ADDENDUM NO. 2

Date: February 28, 2024

CADILLAC HIGH SCHOOL ROOF REPLACEMENT PROJECT

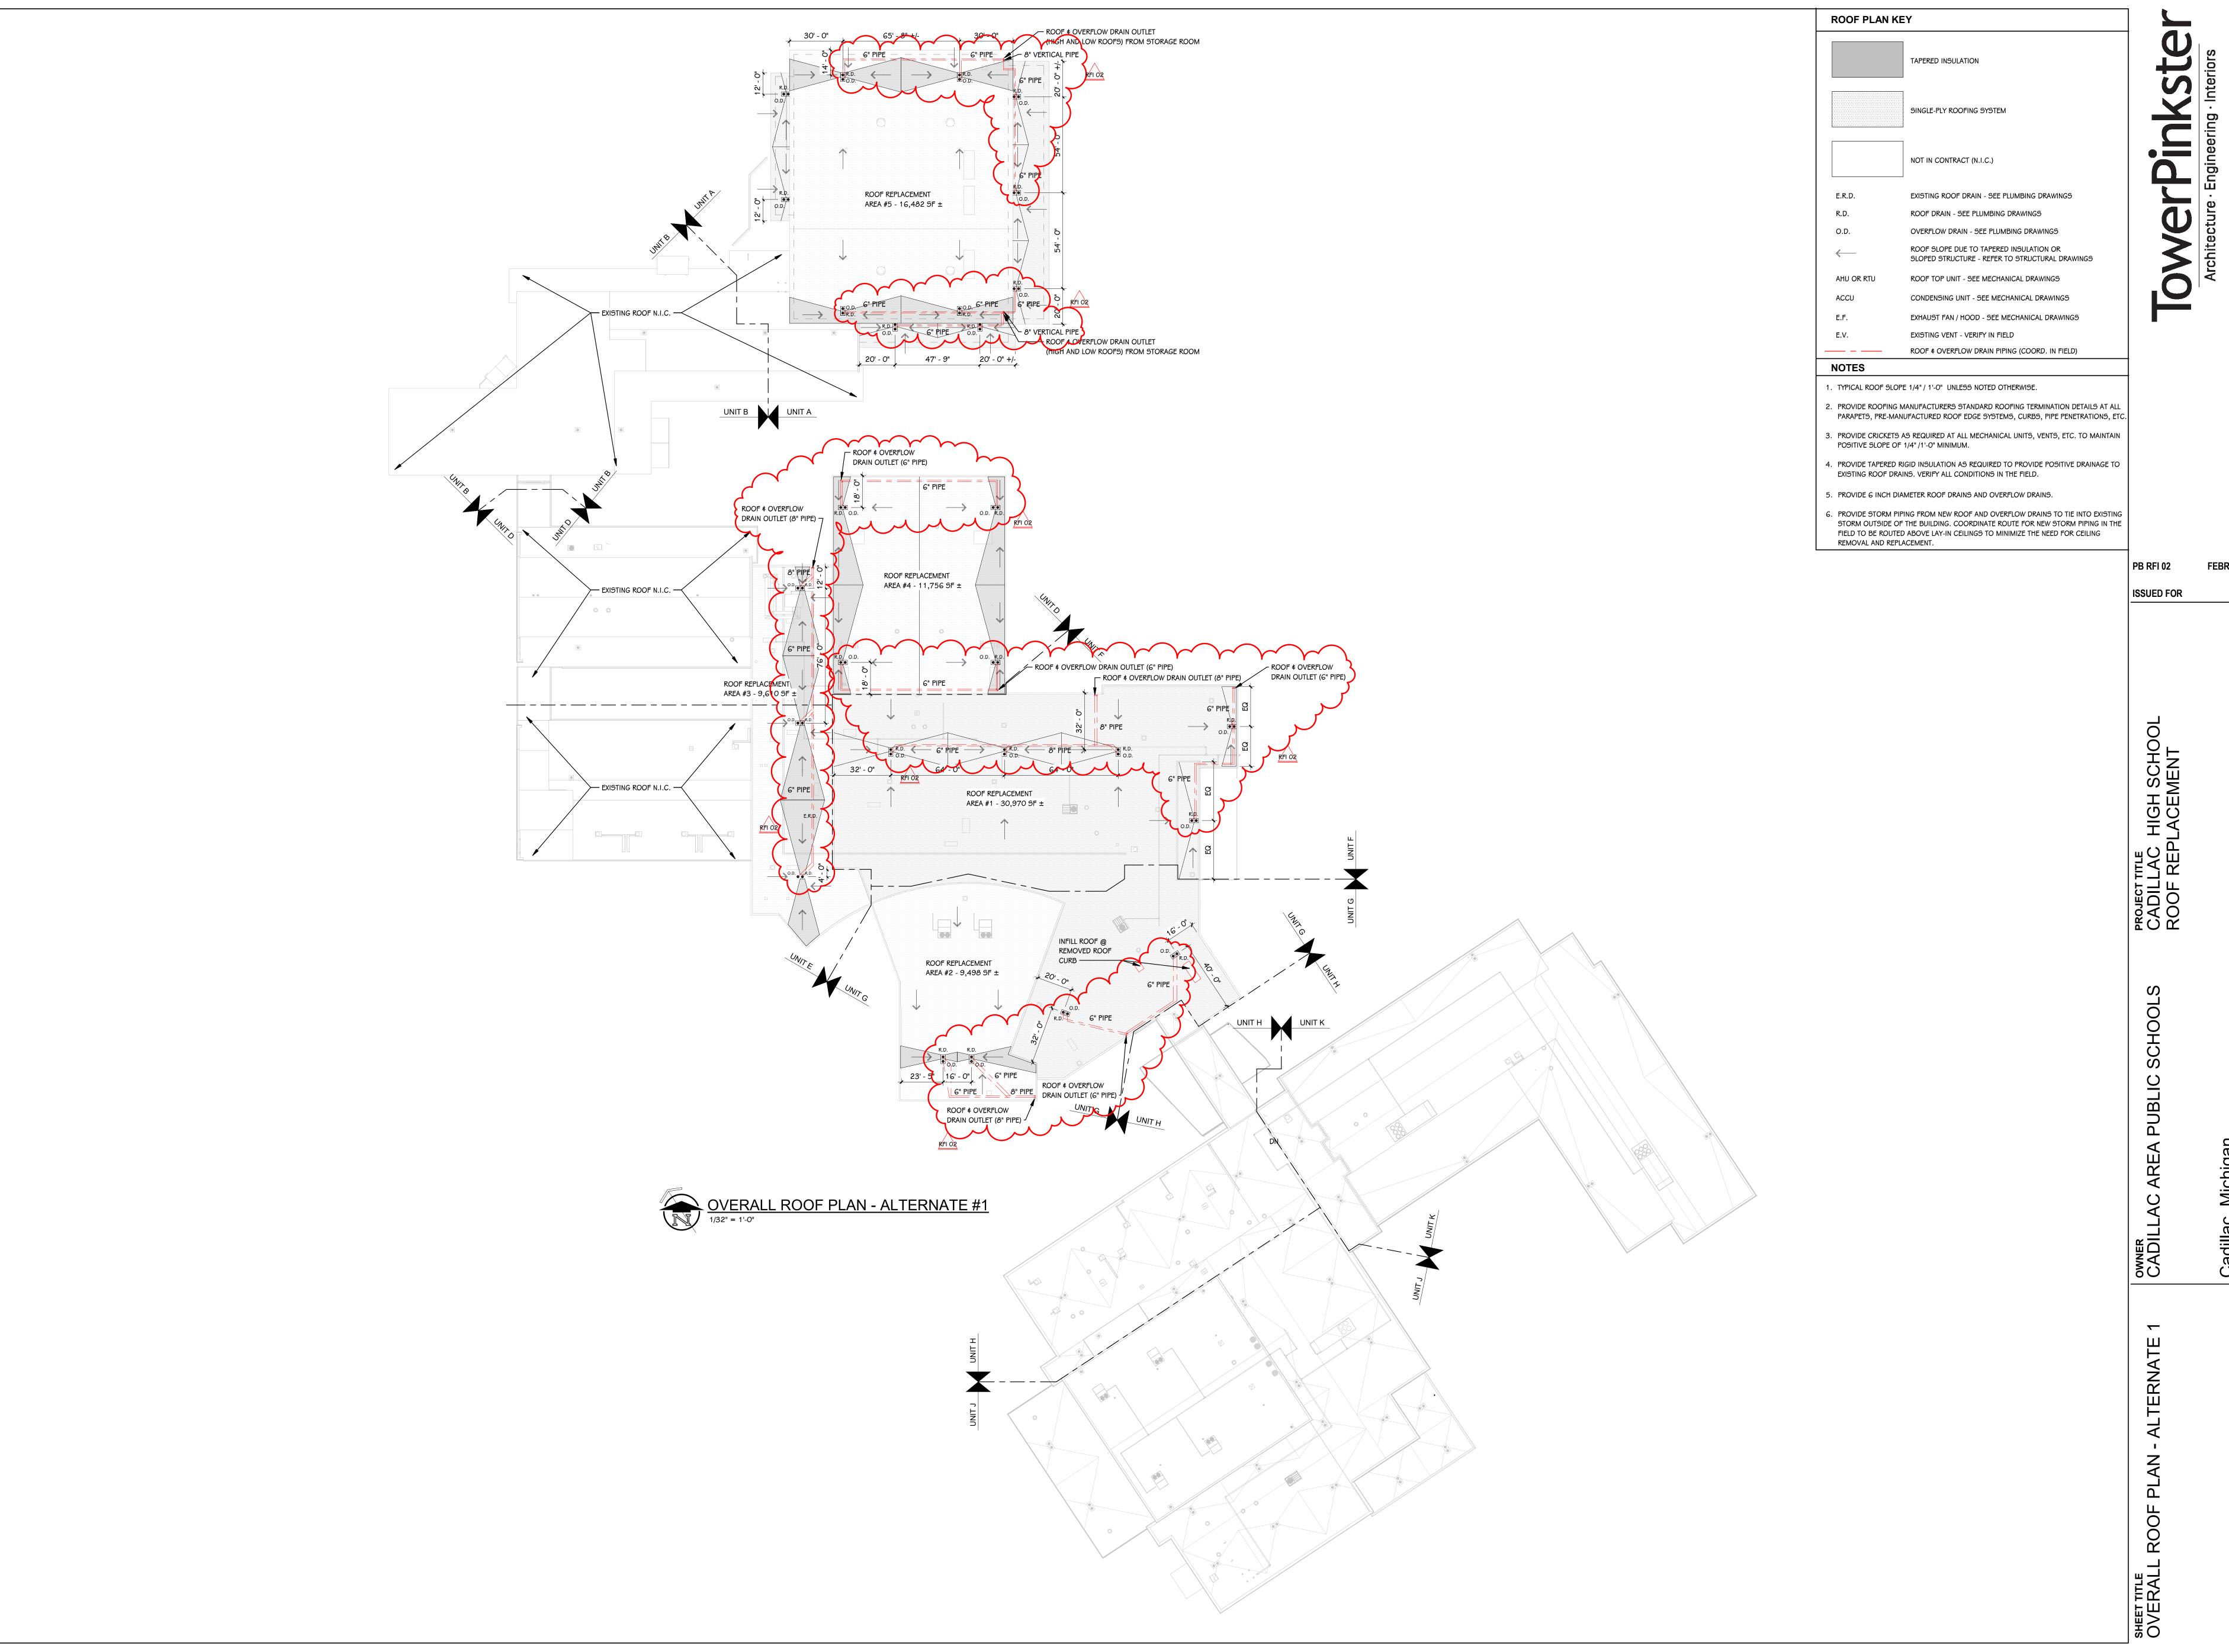
| RFI # | CONTRACTOR QUESTION/DESCRIPTION | DATE | RESPONSE | DATE RESPONSE |
|-------|---|---------|---|------------------|
| 02 | Will there be any upcoming addendums that have plumbing plans with pipe sizes? – D&W Mechanical | 2/27/24 | Provide roof and overflow piping in sizes identified on attached sheet A 803.3 as shown clouded. Verify final pipe sizes in fieldTP | 2/27/24 |
